ONSITE SEWAGE DISPOSAL SYSTEM

PROPERTY ADDRESS: 15081 Roxbury Road

SUBDIVISION: Chase Farm

RE: OSDS Plan
Chase Farm, Lot 7

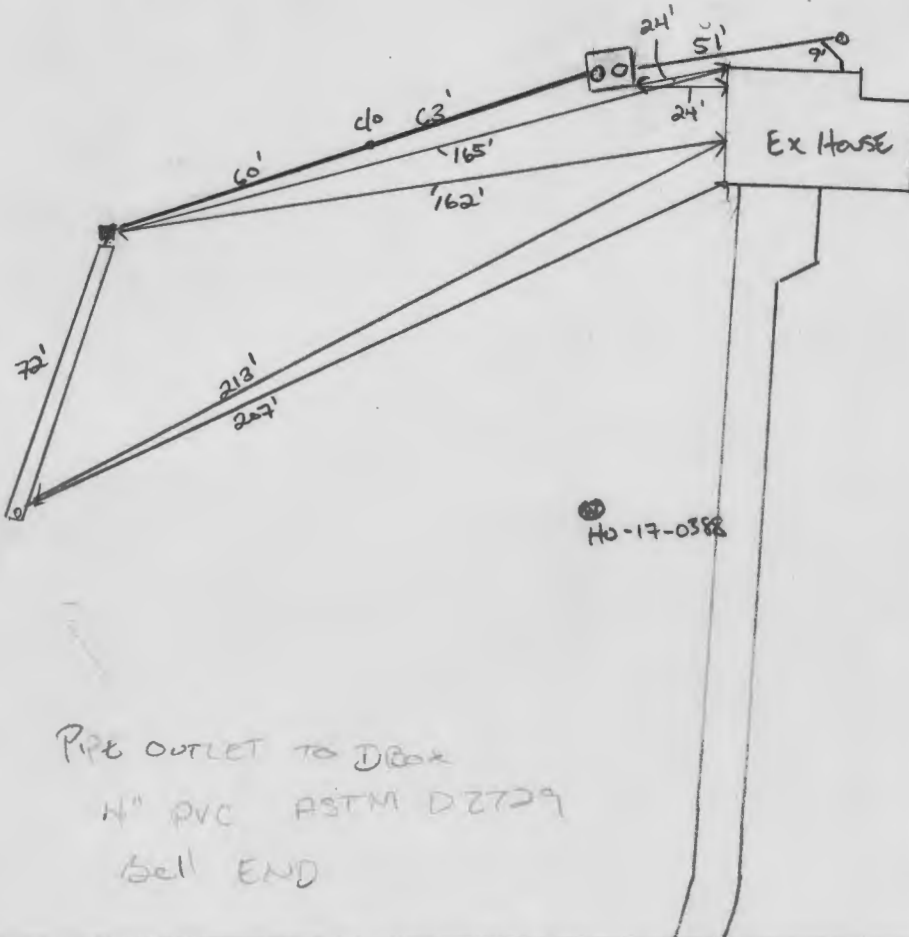
5/7/2019 SDA NOT STAKED. ONLY TRENCH STAKED. CHECKED
CONTOUR.

INSTALLATION: 5/7/2019 SHC NOT INSTALLED. TANK PIT EXCAVATED. TANK

TO ARRIVE THIS AFTERNOON 5/9/2019 TANK SET. C/A SLOT IS ONLY

1". MUST REPLACE 4" PVC ASTM D2729 WITH SCH 40 or

SCH 35 PVC OR COMPERABLE. C/A ADD DBOX BAFFLE. (+)

5/10/2019 OUTLET LINE FROM TANK TO D BOX REPLACED

W/ SCH 40. D BOX BAFFLE ADDED (BRICK). REINSP. SHC. (+)

7/2/2019 SHC INSPECTED. (+)

ON SITE SEWAGE DISPOSAL SYSTEM DESIGN PLAN
LOT 7
CHASE FARM
PLAT #24079

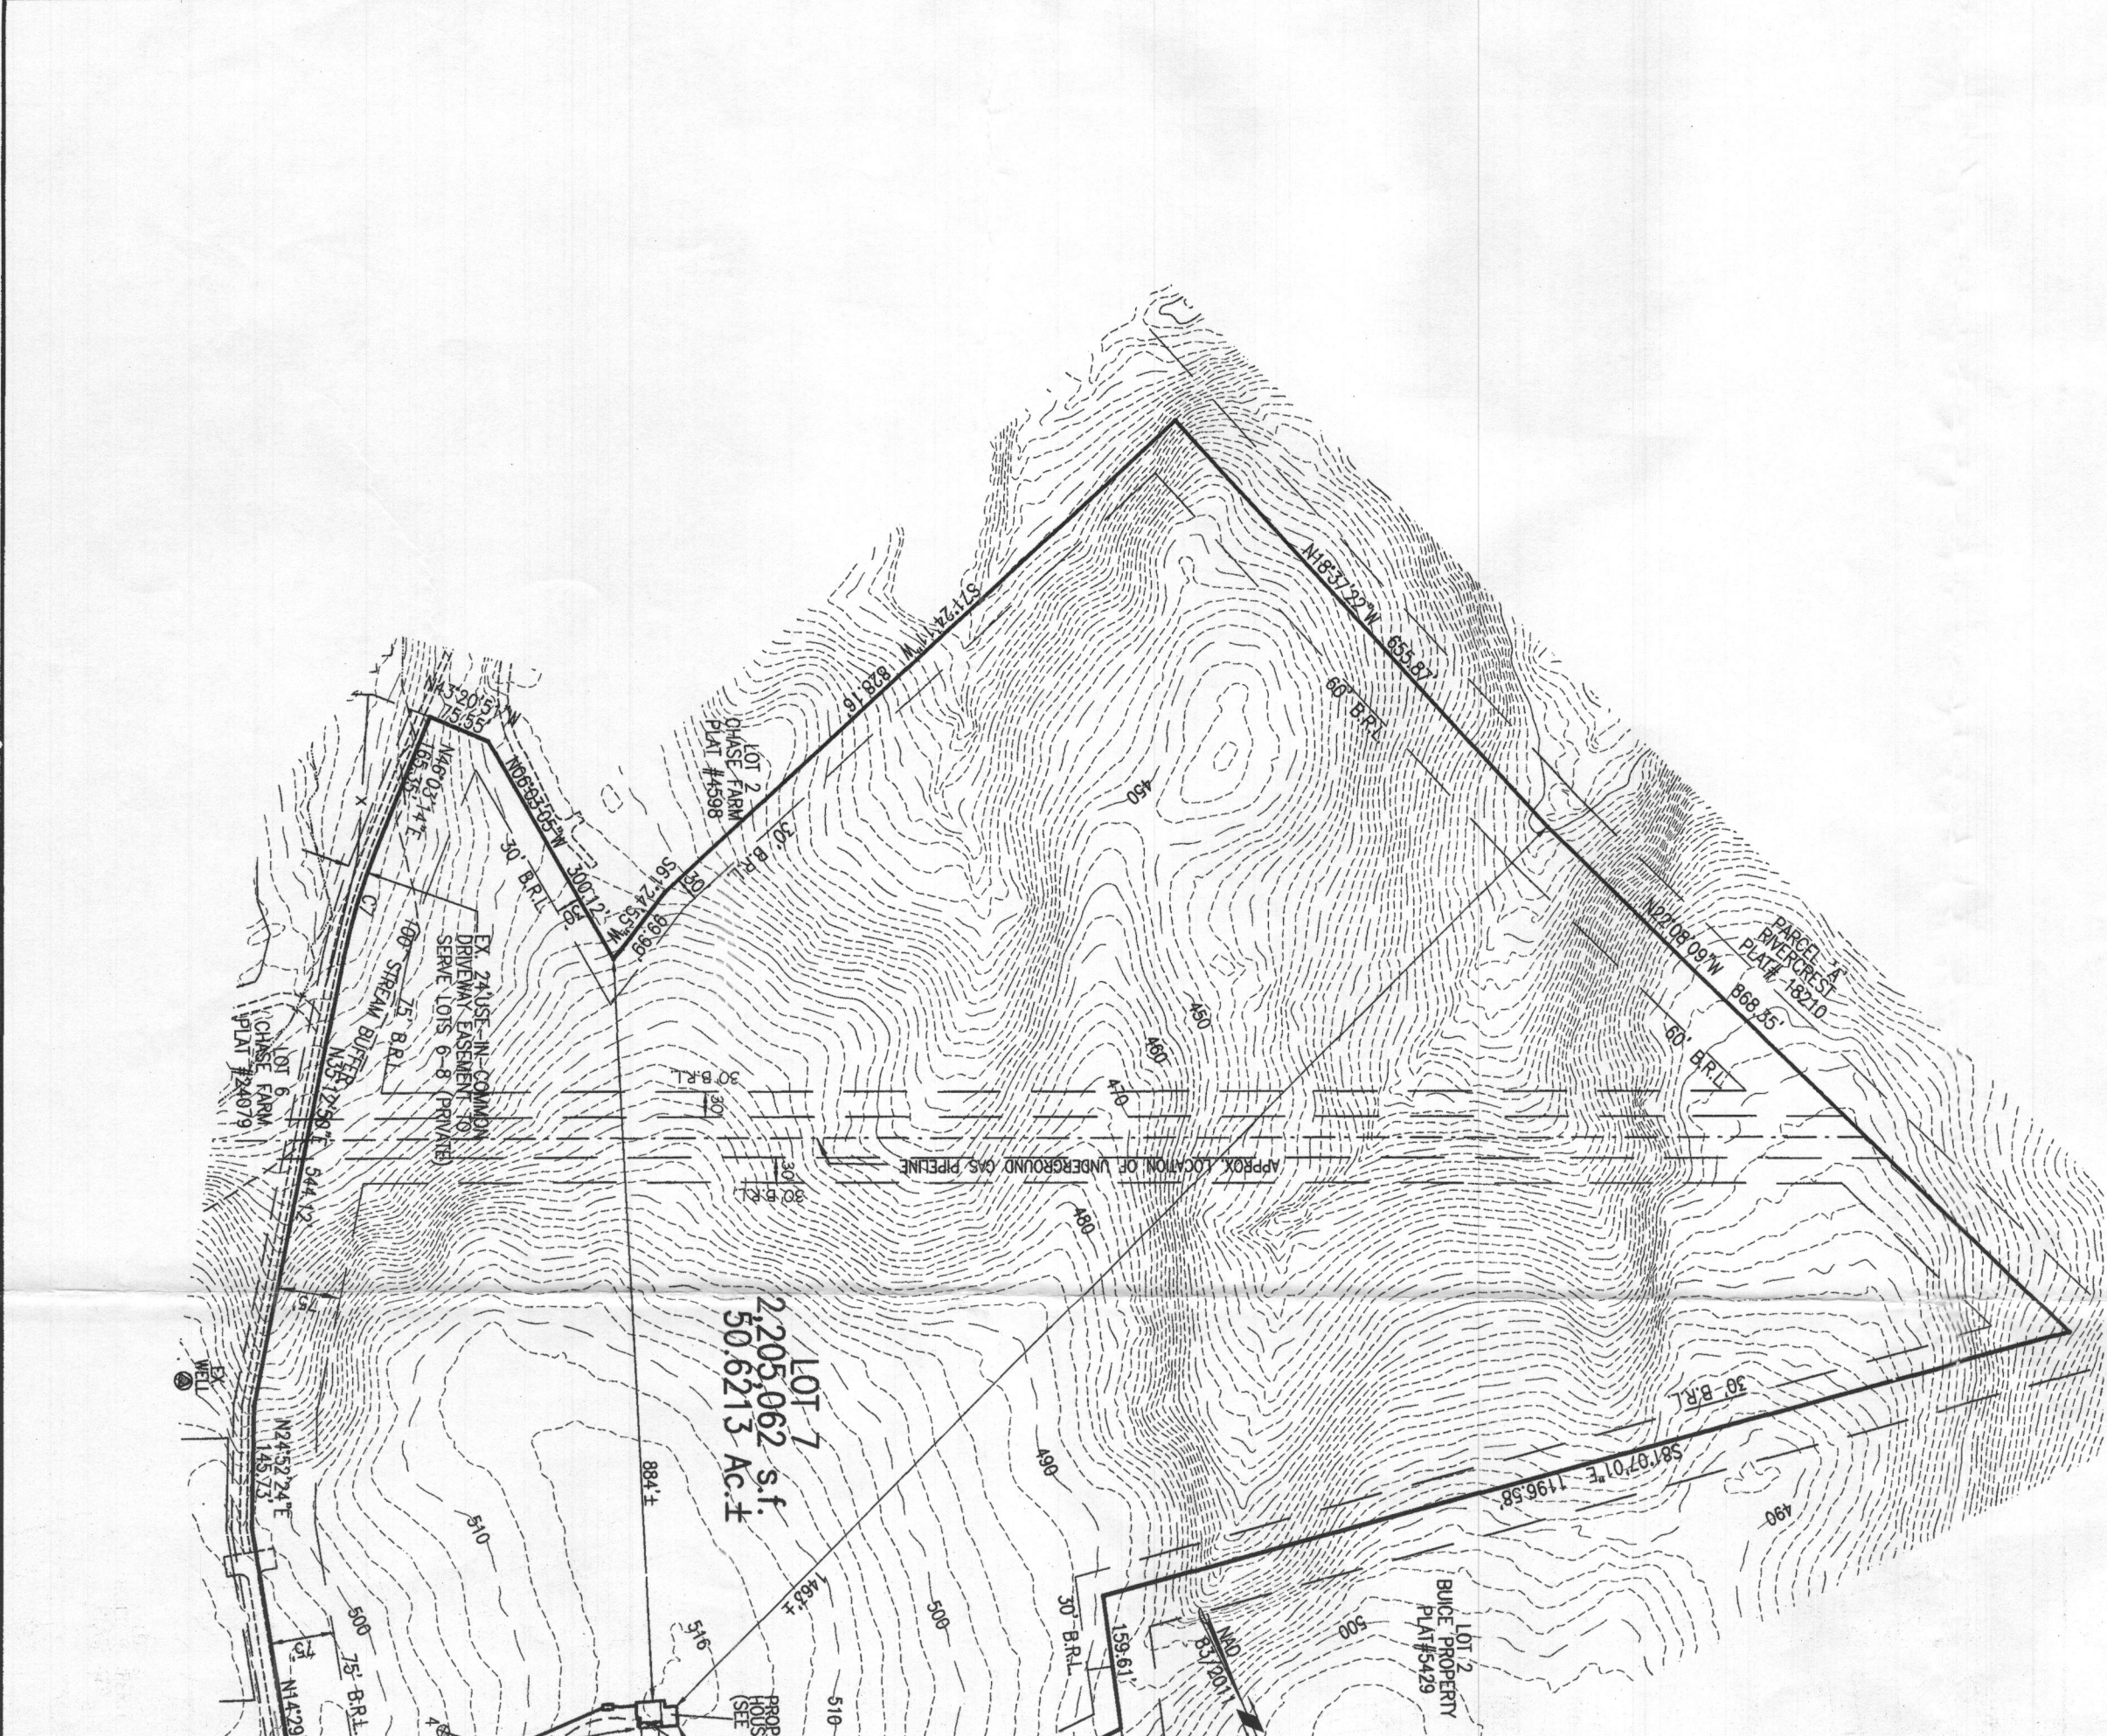
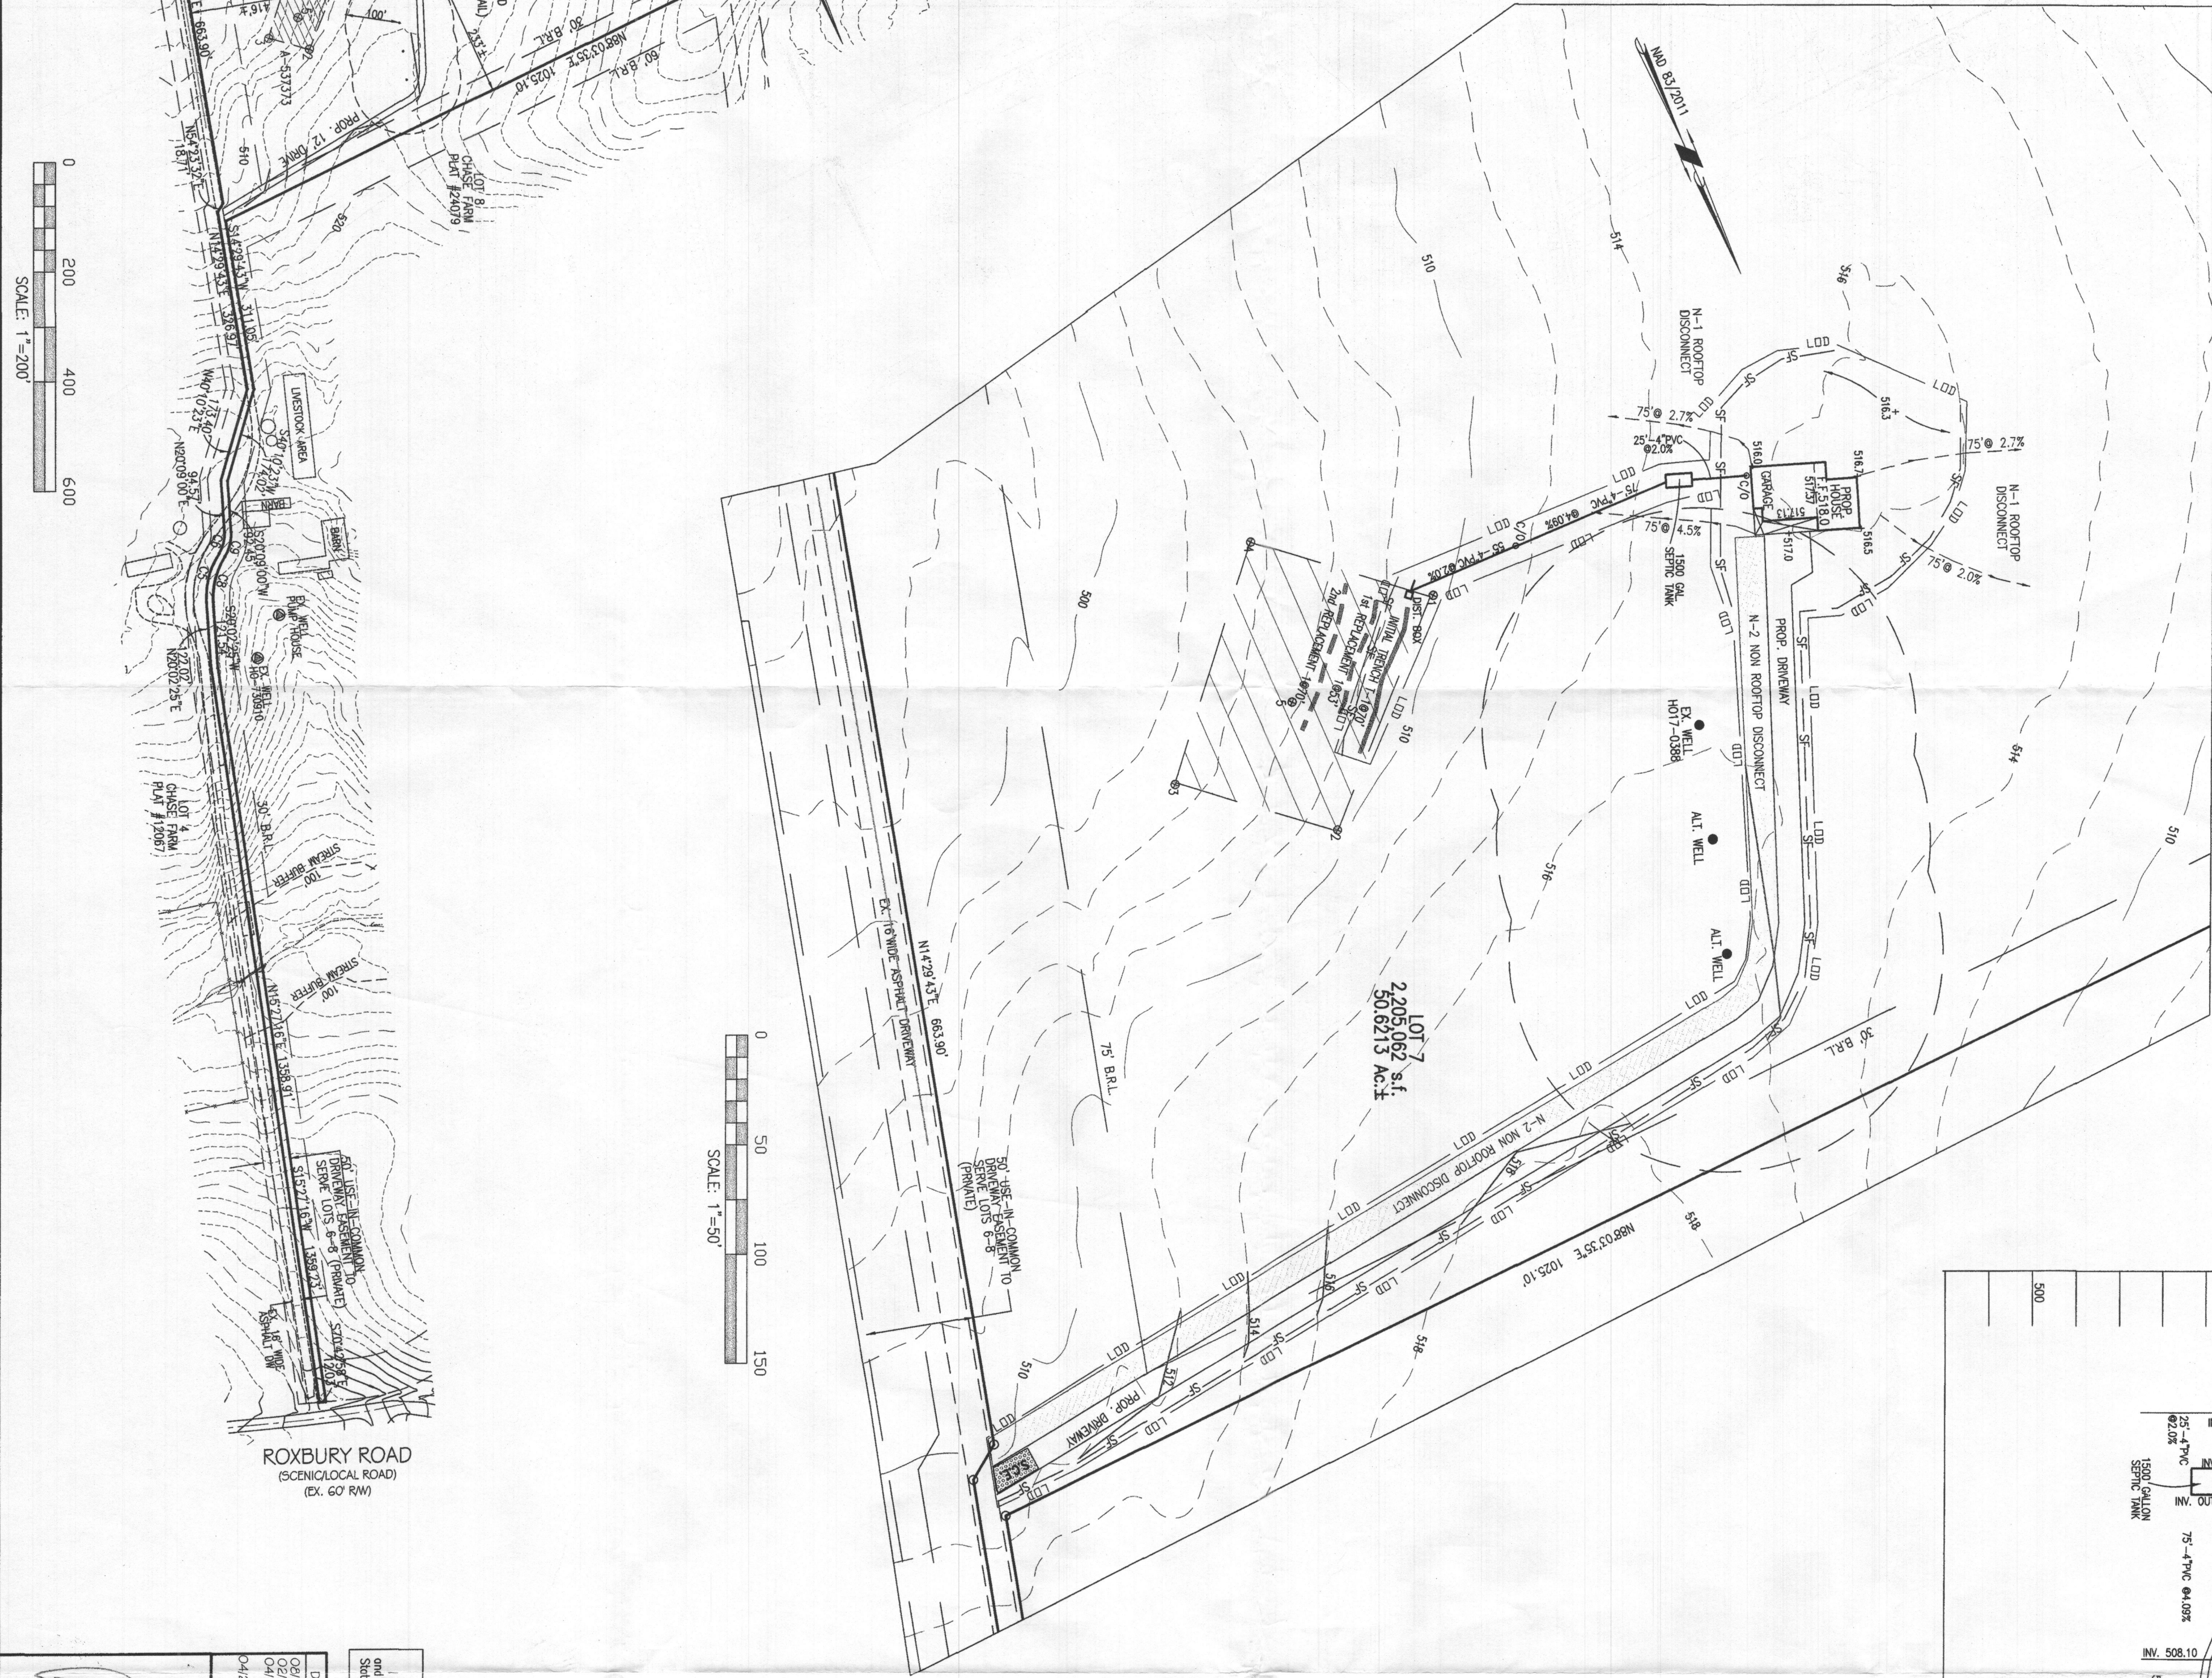
The following comments pertain to the review of the OSDS Plan for Chase Farm, Lot 7:

- 1.) Correct elevations between well and SDA
- 2.) Correct reduction credit for 2nd replacement system (same as initial system)
- 3.) Delete site note #3 as it doesn't apply

REMARKS: Good Day Hank, the plan submitted to reflect change in bedroom count.
Thank you for your review and approval.
